MIL-STD-1660 TESTS

GENERAL DEFENSE CORPORATION

VALUE ENGINEERED CHANGE PROPOSAL

(VECP 0520E0014R-C)

MODIFICATIONS MADE TO SHEET 5:

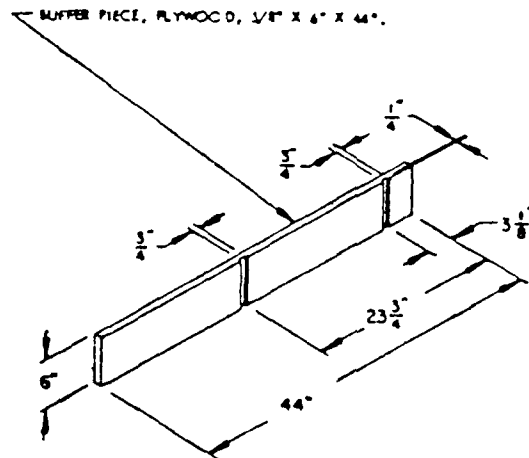
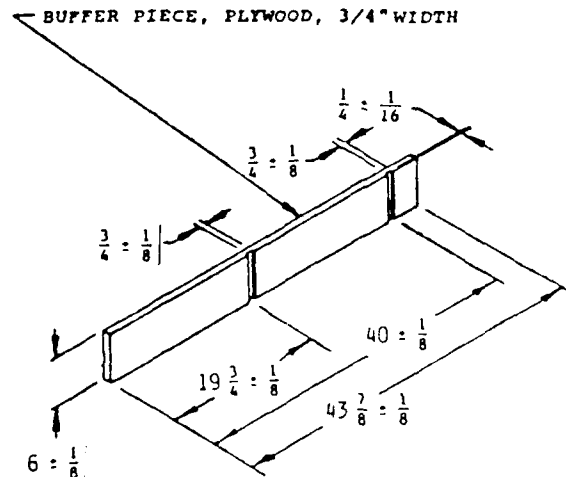
8. DESCRIPTION OF REVISION

OLD:

NEW:

- o Two pallet dunnage components rather than three.
- o 12 nails per dunnage component rather than 6.
- o Less dunnage area.
- o Tighter functional tolerances.

Selection of two pallet dunnage components rather than three is based upon the tolerance range about the container middle ring. Due to the dimensioning practice in the present design of the wood pallet, it is not possible to maintain a tolerance around the middle ring which provides satisfactory functional characteristics. Accordingly, this section of the pallet dunnage was eliminated. In addition, the small strip of dunnage at the container base was eliminated since it is not required to constrain movement.

Vendor feedback has identified problems with the current design surviving shipment between the wood pallet manufacturer and the LAP facility. GDC has reviewed this problem and recommends that six (6) additional nails be used per dunnage component.

MODIFICATIONS MADE TO SHEET 5 (SHEET 2 OF 2):

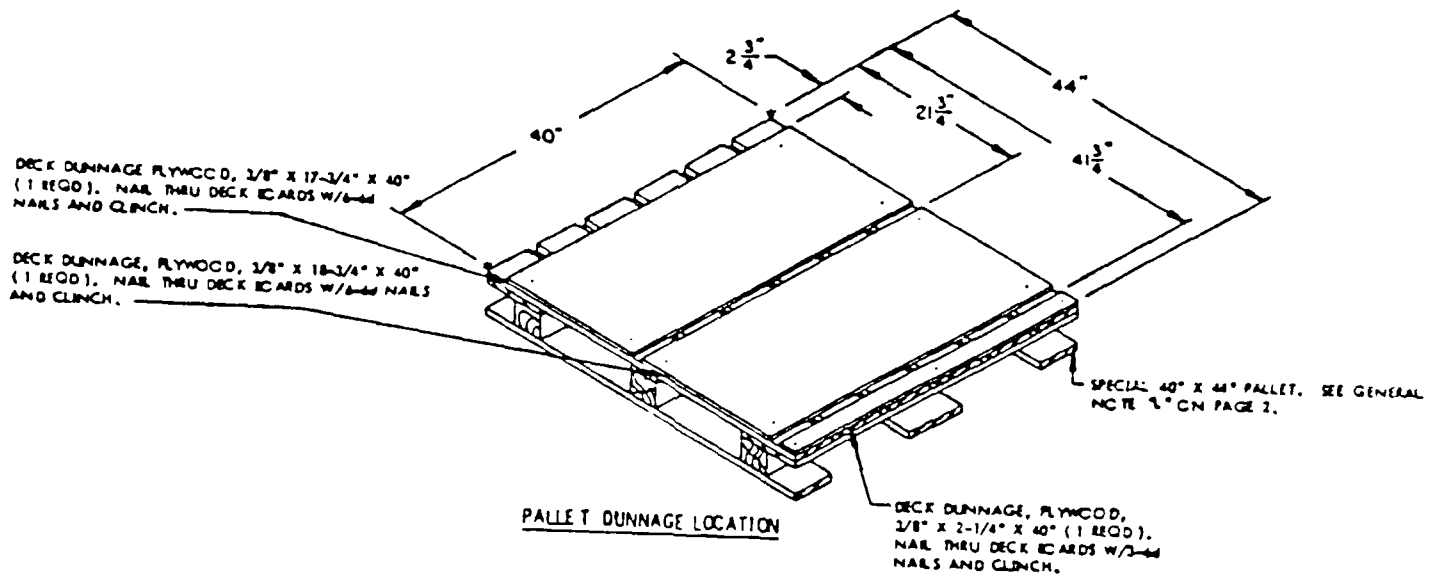
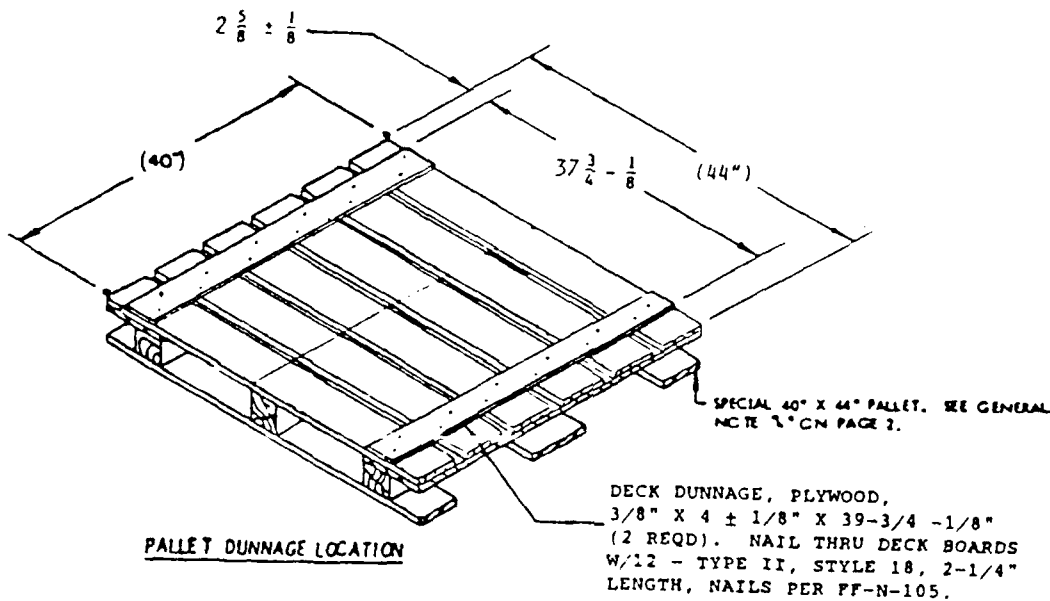
<b>1. ORIGINATOR NAME AND ADDRESS</b> GENERAL DEFENSE CORPORATION, TACTICAL SYSTEMS DIVISION 10101-9th Street North, St. Petersburg, FL 33716		<b>DATE</b>  	<b>MFR. CODE</b> OAYM6	<b>MOD. NO.</b>  
<b>2. TITLE OF DOCUMENT</b> UNITIZATION PROCEDURES FOR COMPLETE ROUNDS PACKED IN CYLINDRICAL METAL CONTAINERS ON 4-WAY ENTRY PALLETS.		<b>3. MFR. CODE</b> 28620	<b>4. DOCUMENT NUMBER</b> 19-48-4079/7B-20PM100	
<b>7. CONFIGURATION ITEM (OR SYSTEM) TO WHICH ECP APPLIES</b>  CARTRIDGE, 120MM, TPCSDS-T: M865		<b>5. REVISION LETTER (CURRENT)</b> -		<b>6. ECP NO.</b> 0520ECC14 R-
<b>8. DESCRIPTION OF REVISION</b>  MODIFICATIONS MADE TO SHEET 5 (SHEET 1 OF 2):  <u>OLD:</u>

NEW:
